ADDRESSEES	: ABC Customer Care and Parts Source Owners and operators of coaches listed under 'Application'
VEHICLE MODEL	: CX45, TX45
SYSTEM/SUBSYSTEM	: 6.10 Transmission – Oil filler tube assembly
BULLETIN TYPE	: Field Change Program
DATE	: March 12th, 2018
SUBJECT	: Installation of improved angle bracket near transmission oil filler cap
TERMS & CONDITIONS	: Refer to the warranty section further in this Bulletin

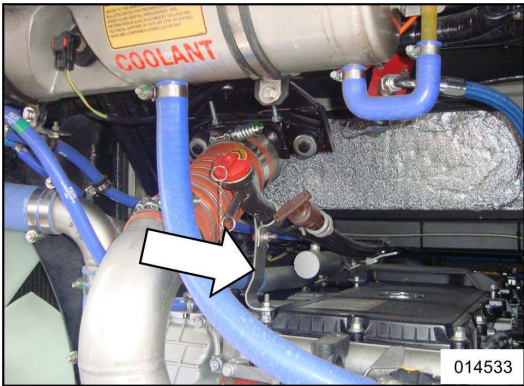
It has come to the attention of Van Hool that on the above mentioned vehicles the angle bracket located at the transmission oil filler cap is prone to breaking due to vibrations of the pipe assembly.

Step	Action
1	Open the engine compartment rear door.
2	Change the transmission oil filler pipe angle bracket located near the filler cap by angle bracket 11589843 from the kit.  Figure 1: Angle bracket 11589843 installed
3	Notify ABC Companies by mail. Write the text "SB1494 executed for VIN....." in the mail and send the mail to warranty@abc-companies.com .
4	For ABC Companies only: register through the registration button located behind the Service Bulletin on the Van Hool customer portal. Write the text "SB1494 executed" in the field "Remark". Labor allowance will only be awarded after Van Hool has received the registration.

Components		
VH reference	Description	Qty.
11589843	Angle bracket	1
